NOTICE OF DECISION

Case File: T2-03-084

Permit: Design Review

Summary: Design Review Request for the Holbrook Fire Station.

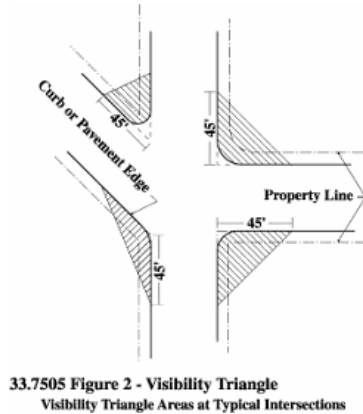
11. Prior to land use sign off of the building permit, the applicant or his representative shall modify the site plan to show the proposed freestanding sign outside of the Vision Clearance Area for each access drive. In order to establish the Vision Clearance Area, please draw two, 45 long lines along the sides of the access drive and Cleetwood Avenue intersections. Then, link the lines together to form a triangle. The area within the triangle is the Vision Clearance Area. Remove the sign for these restricted areas. See the following detail -

[MCC 33.7465(D), 33.7505(NN)
& Figure 2]
